INITIAL ASSESSMENT REPORT
OF
ISLAND EAST TRANSFER STATION

CES CONSULTANTS IN ENVIRONMENTAL SCIENCES (ASIA) LTD

May 1993

FIGURE 1 : SITE LOCATION

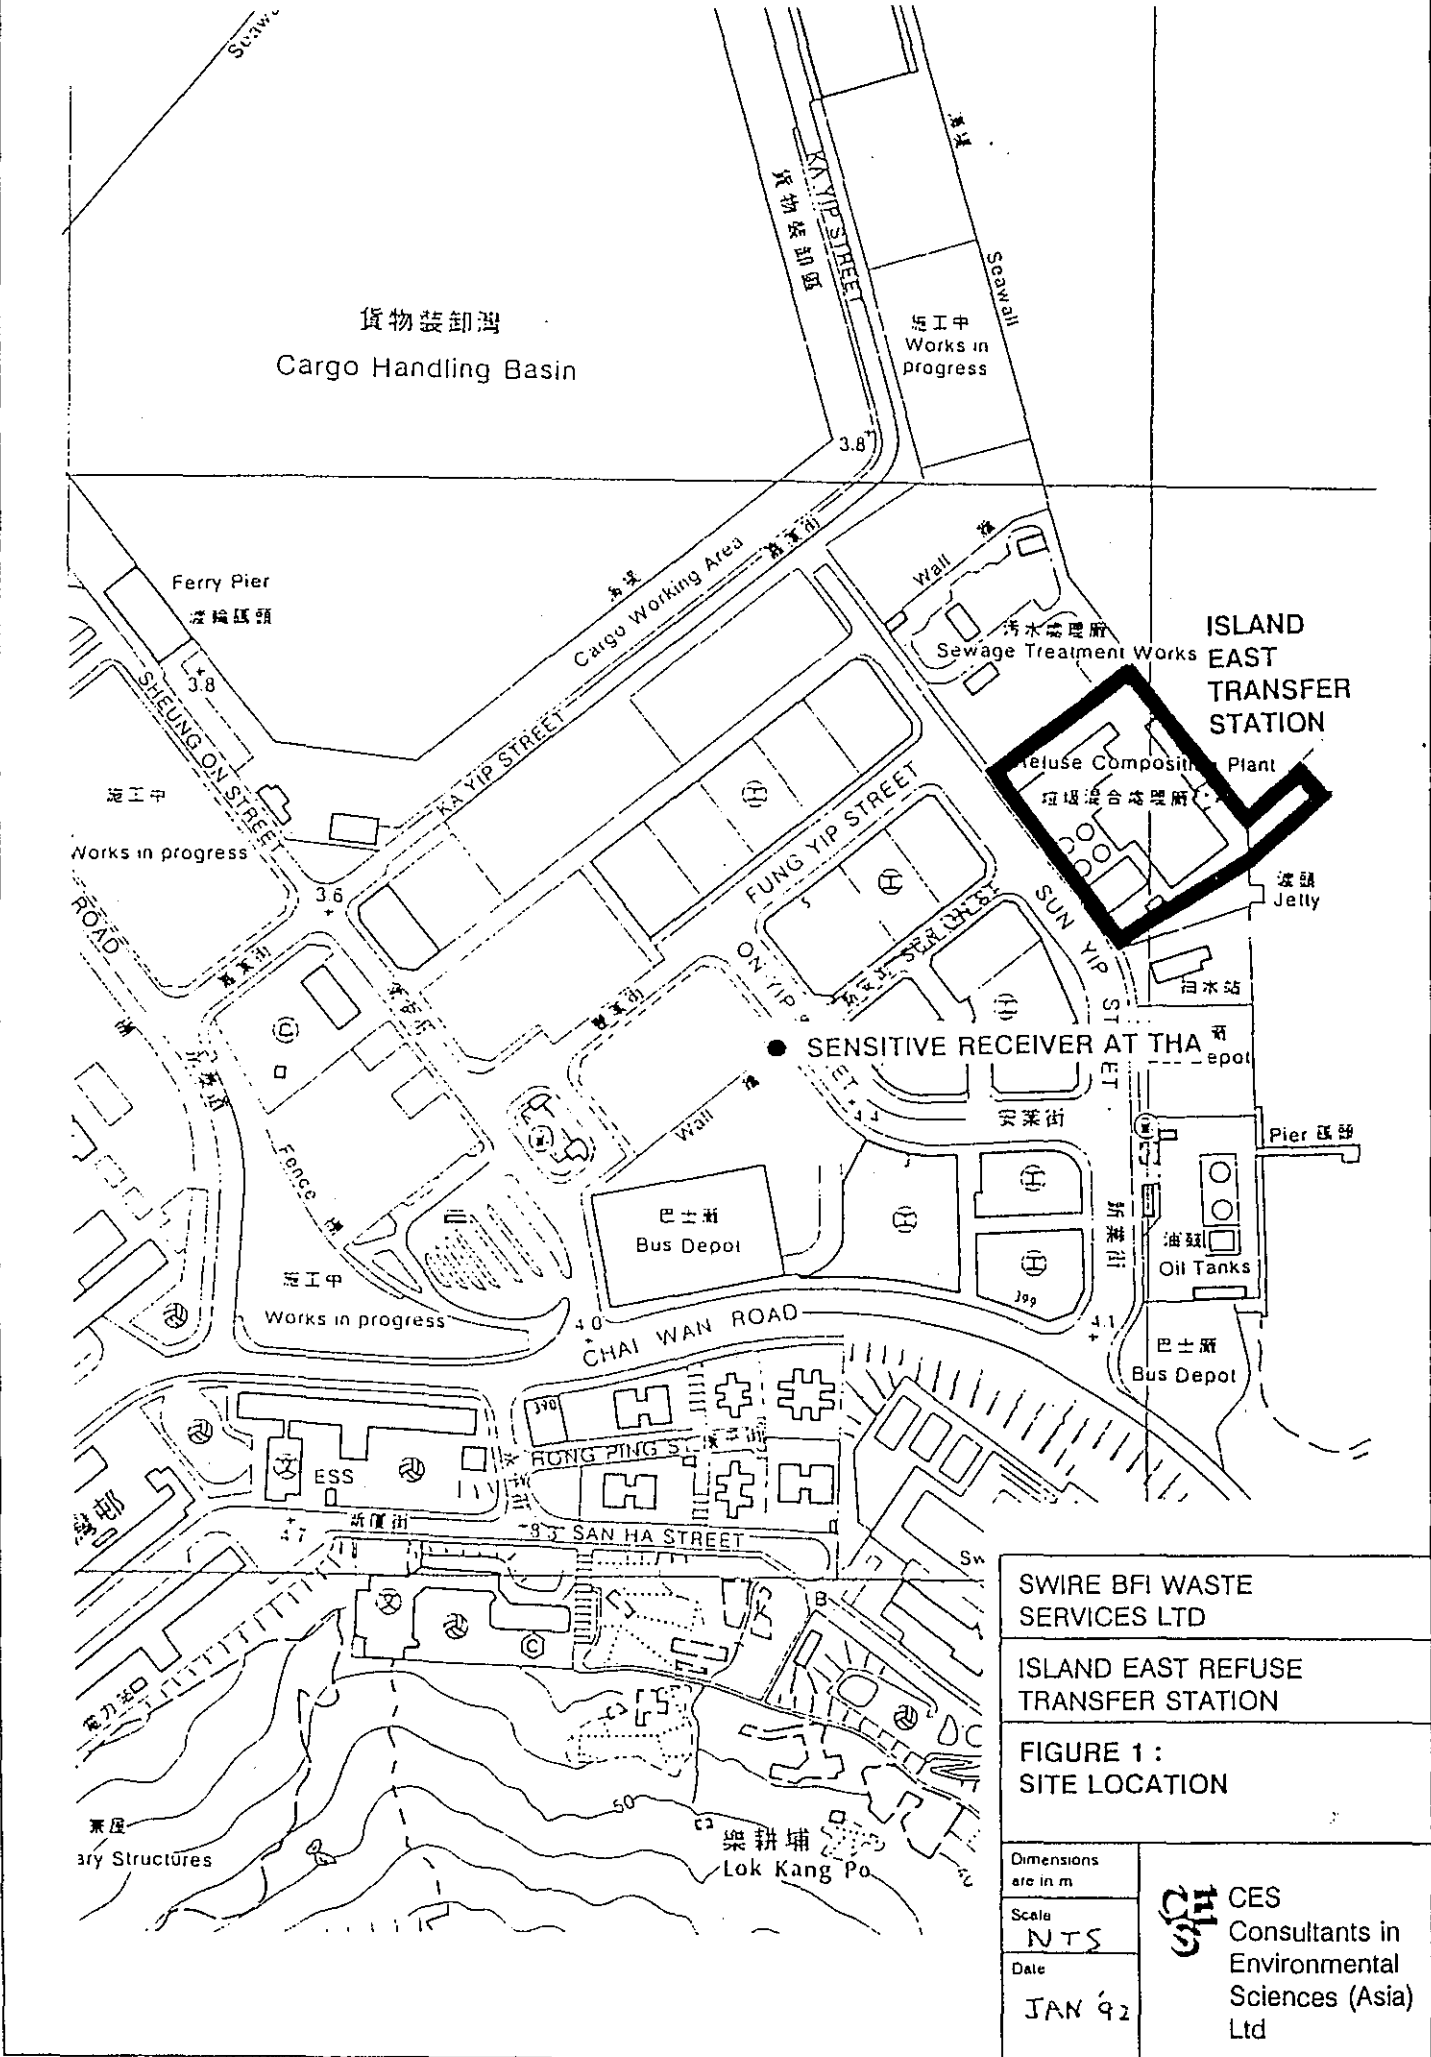
You should indicate on a drawing the location of the sensitive receivers. Will you consider the accumulative effect of the construction activities?

33 Figure 1 (Site Location Plan) and Section 3.1 (Air Description)
The figure and the section should be revised as per the current Siu Sai Wan ODP.

The location of the sensitive receivers will be indicated on Figure 1, a copy of which is attached to these responses. Should construction activities result in cumulative impacts upon the environment, they will be addressed in the Construction Key Issues Report.

SWIRE BFI WASTE SERVICES LTD	
ISLAND EAST REFUSE TRANSFER STATION	
FIGURE 2 : SITE LAYOUT PLAN	
Dimensions are in m	 CES Consultants in Environmental Sciences (Asia) Ltd
Scale N T S	
Date JAN '92

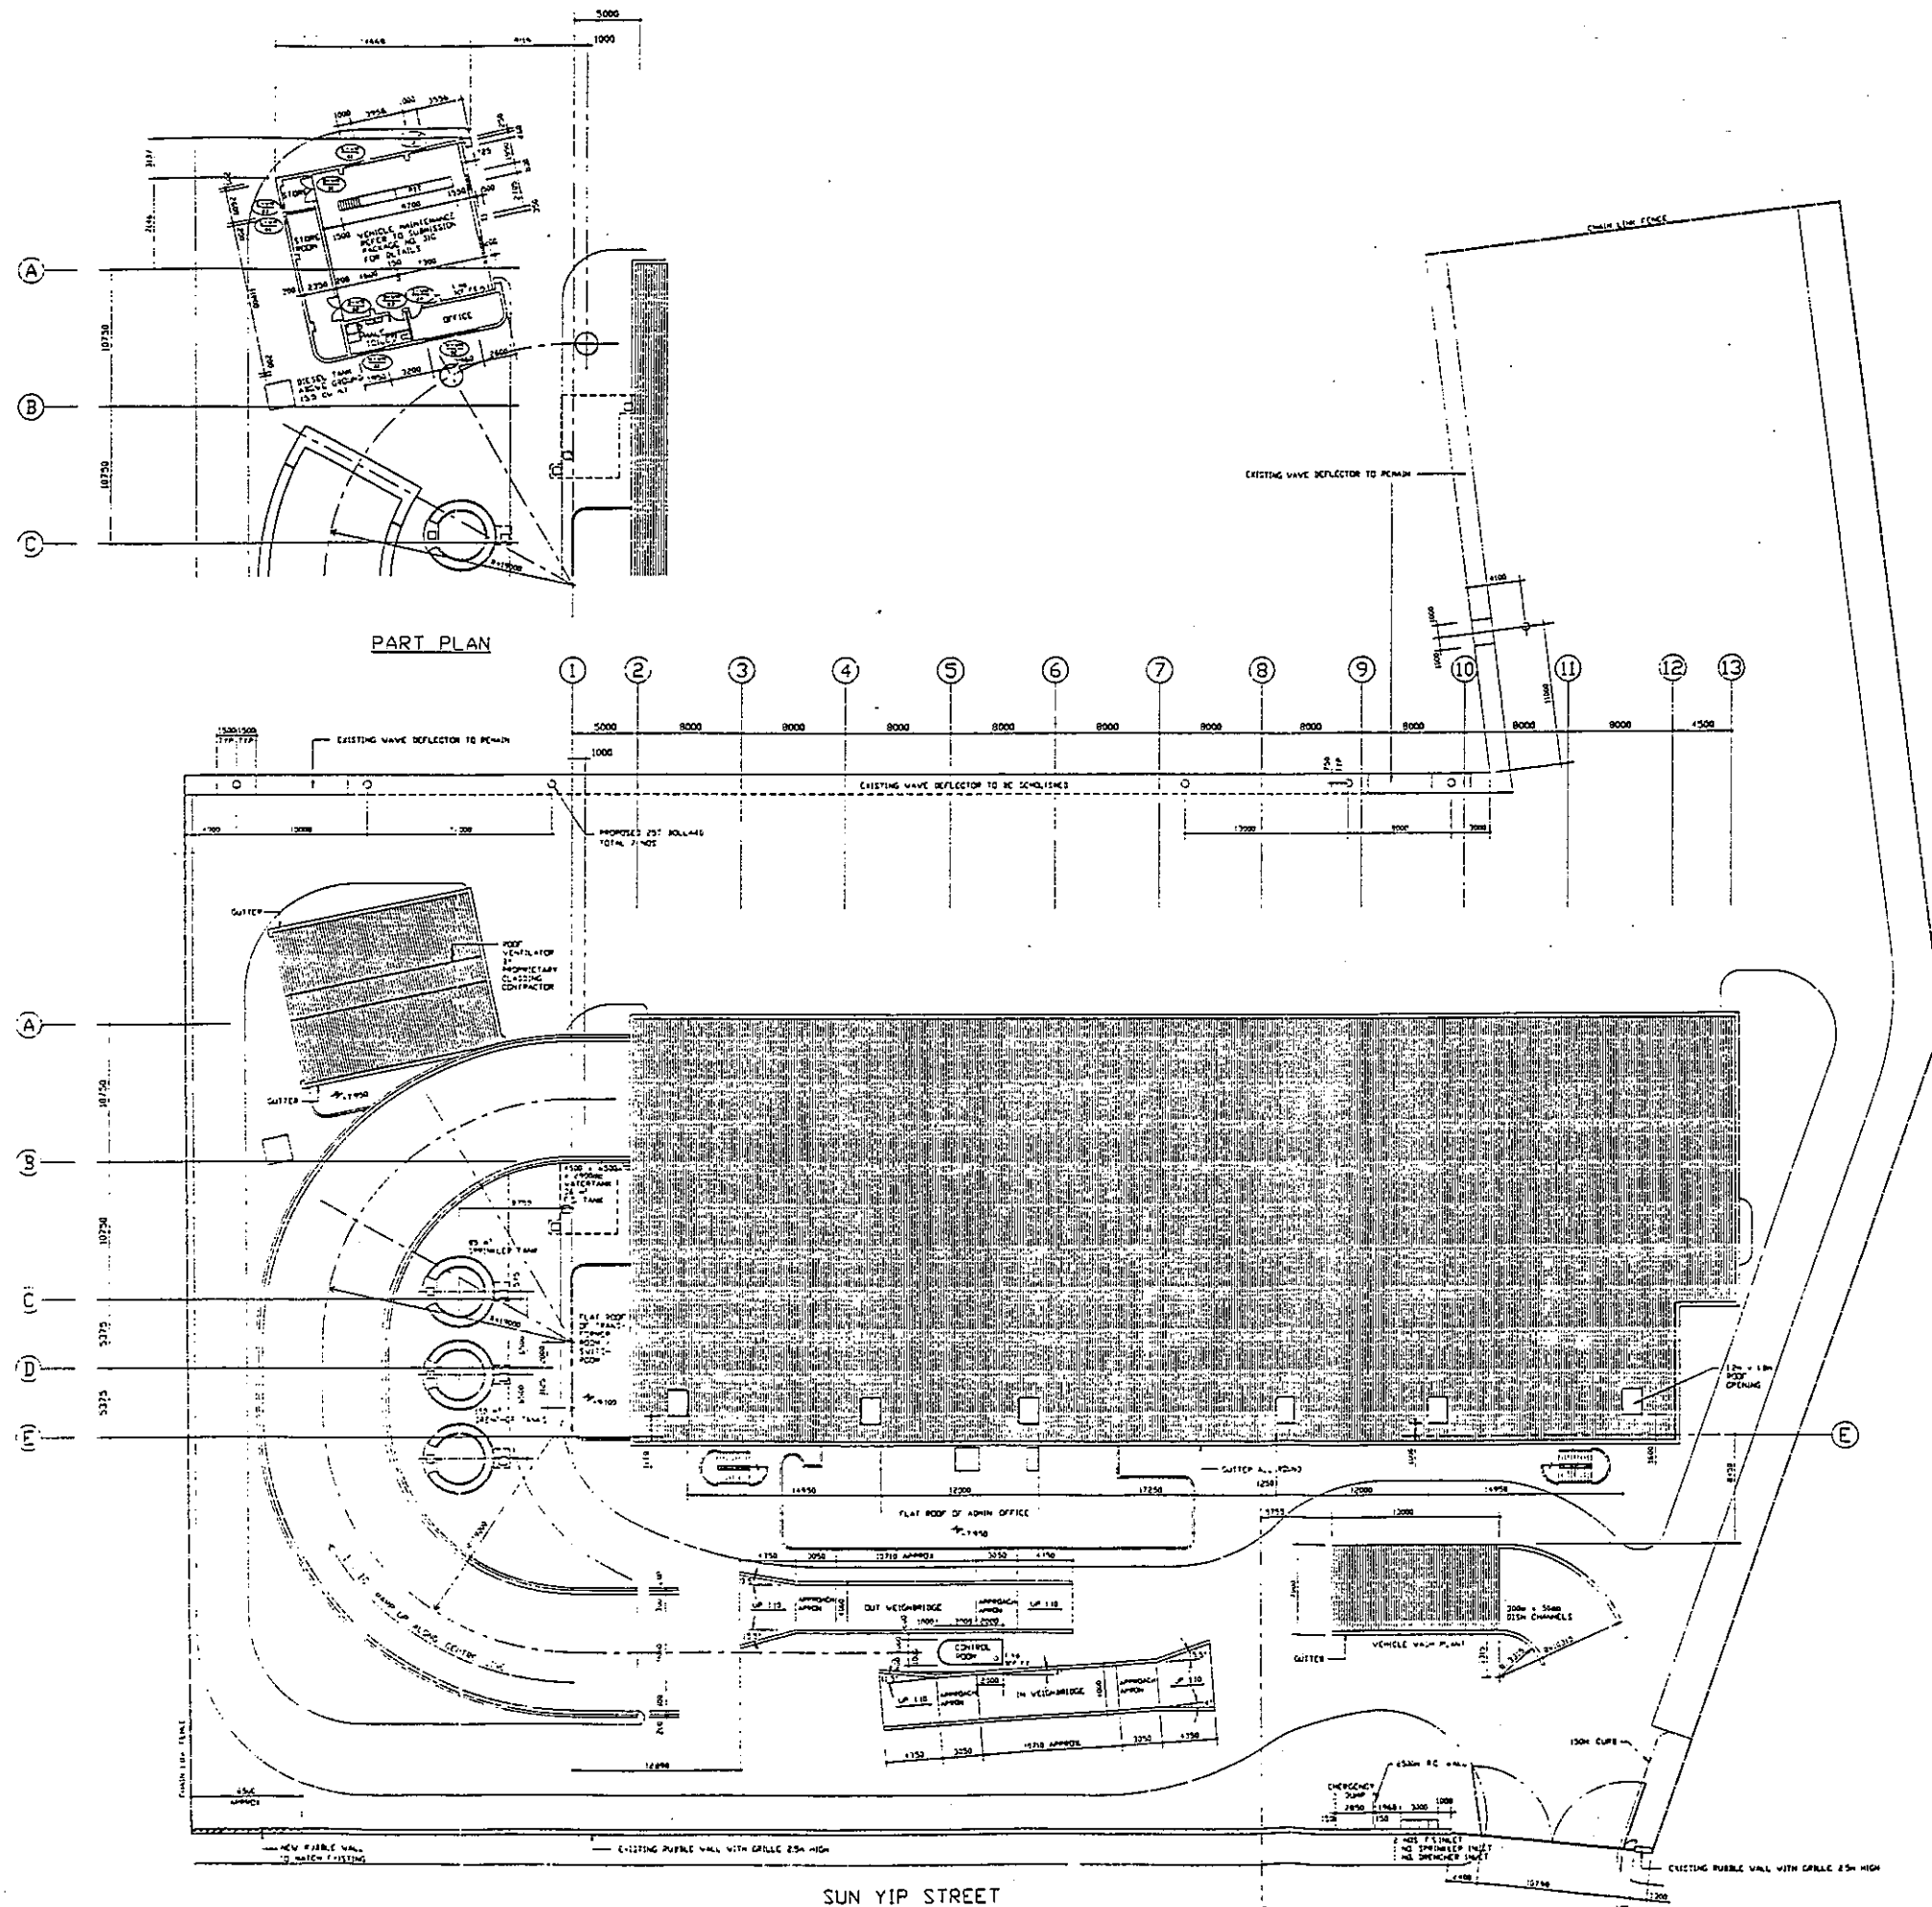
- 19 Is there any information on the total numbers of RCVs owned by the USD that are using the existing temporary refuse disposal facilities?
- 20 Figure 2
Is the vehicle was plant a "wheel washing" plant only? Is it an enclosed structure? Does it need any operator?

34 Figure 2 (Site Layout Plan)
According to HKPSG, considerations should be given to the provision of fully enclosed station. Obviously, Figure 2 does not comply with the HKPSG's requirement which should be followed as far as possible.

ISLAND EAST TRANSFER STATION CO. LTD.	
ENVIRONMENTAL IMPACT ASSESSMENT	
FIGURE 4.1 : LOCATIONS OF SENSITIVE RECEIVERS (NOISE & AIR)	
Dimensions are in m	 CES Consultants in Environmental Sciences (Asia) Ltd
Scale	
Drawn by	
Date

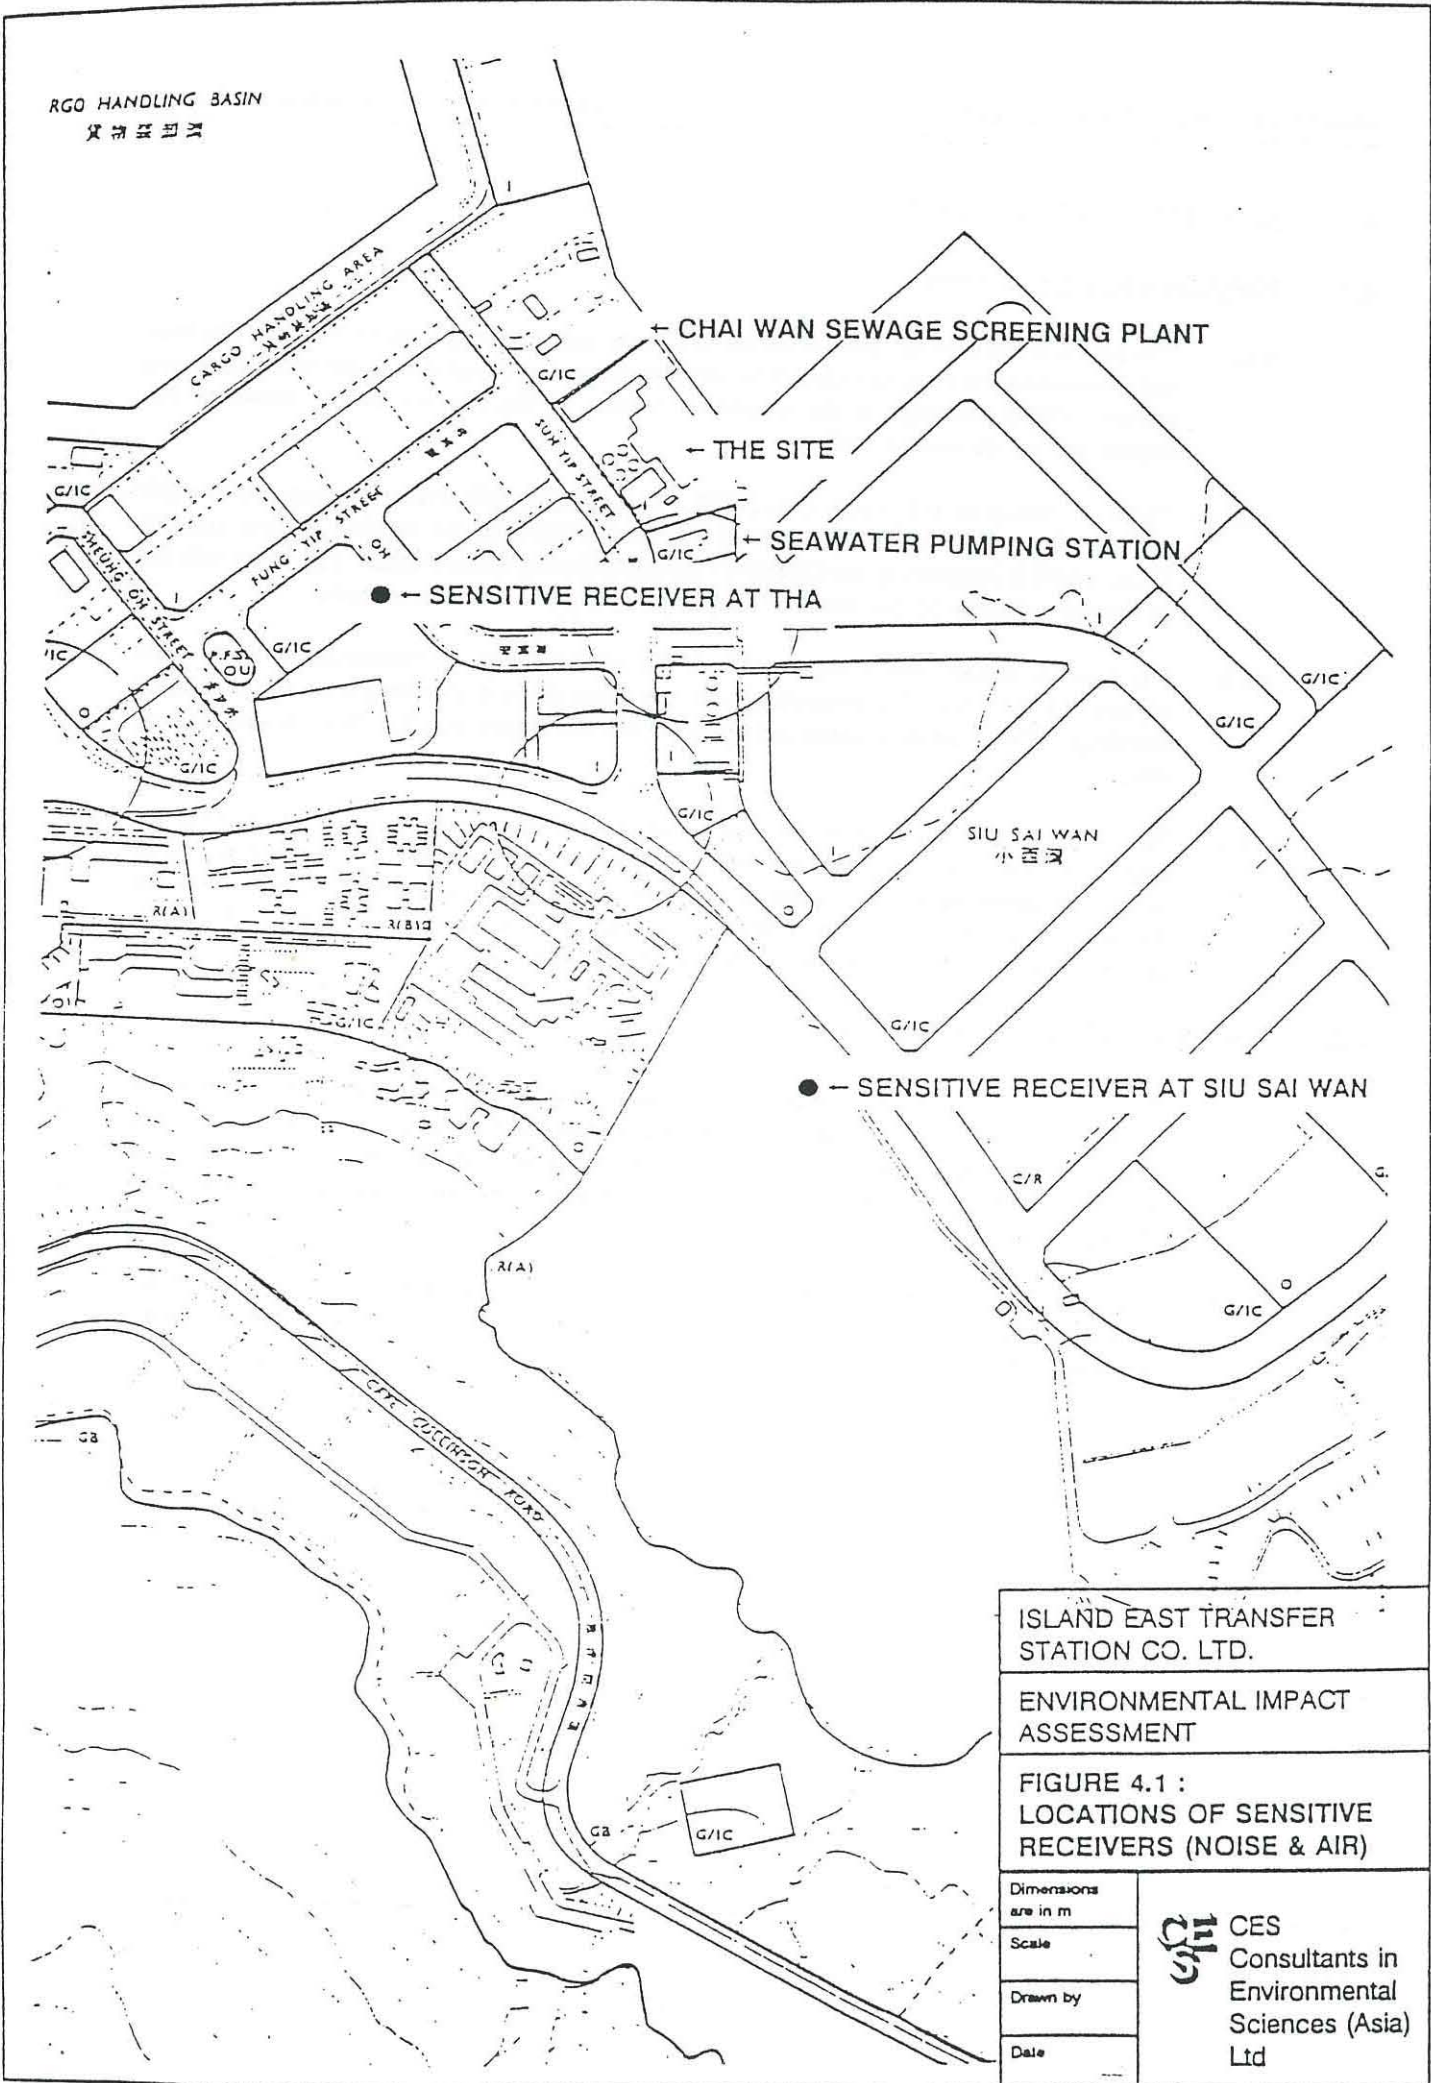
- 10) Para. 4.1.1
- Please show on Fig. 4.1 the location of the Chai Wan Sewage Screening Plant and the Seawater Pumping Station for clarity.
- 11) Para. 5.3.2
